**TOWN OF ERIE
BOARD OF TRUSTEES MEETING
February 13, 2018**

SUBJECT: Sketch Plan Review of the proposed Erie Village Filing 5 single-family, single-family live/work, multi-family, and commercial development within the Erie Village PD.

ERIE VILLAGE FILING 5 SKETCH PLAN

TOWNSHIP 1 NORTH, RANCH 69 WEST OF THE 6TH P.M.
TOWN OF ERIE, BOULDER COUNTY, COLORADO
15.29 ACRES INCLUDING PARCEL X, 77 LOTS, 6 TRACTS
SK-000916-2017

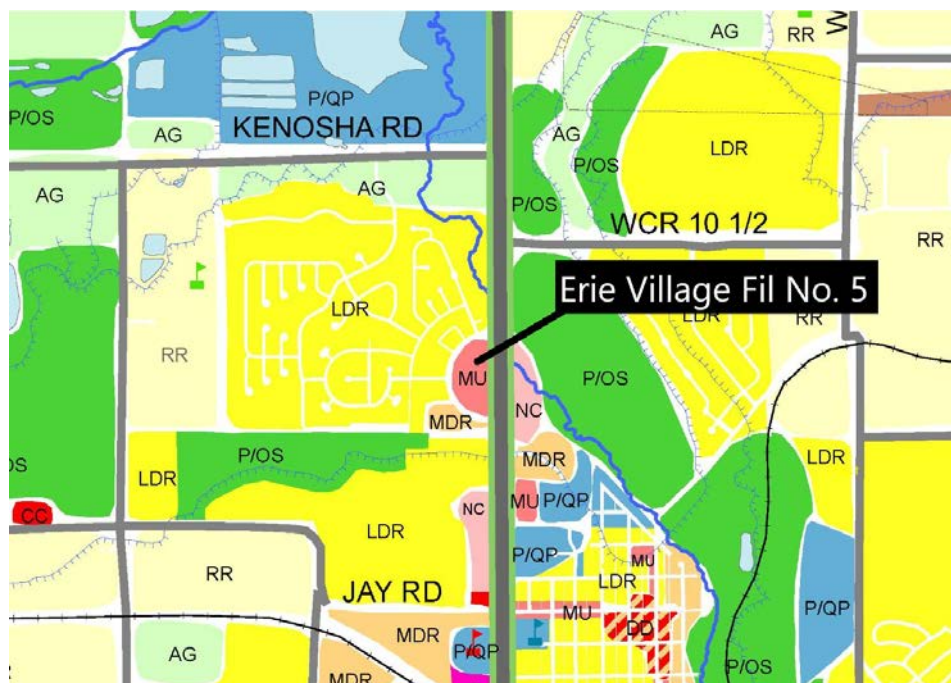
Access into the site is proposed from several locations along C.W. Bixler Boulevard. The applicant's proposed Sketch Plan includes construction of the roads within the Filing 5 area. Staff would require the roads within Filing 5 to incorporate detached sidewalks and tree lawns to meet Town design standards.

County Line Road to the east of Filing 5 is considered to be a community gateway by the UDC. As a gateway, additional design standards shall apply. These standards include a 30 foot landscape buffer, an eight foot sidewalk, screening of parking, and limits on fencing and signage.
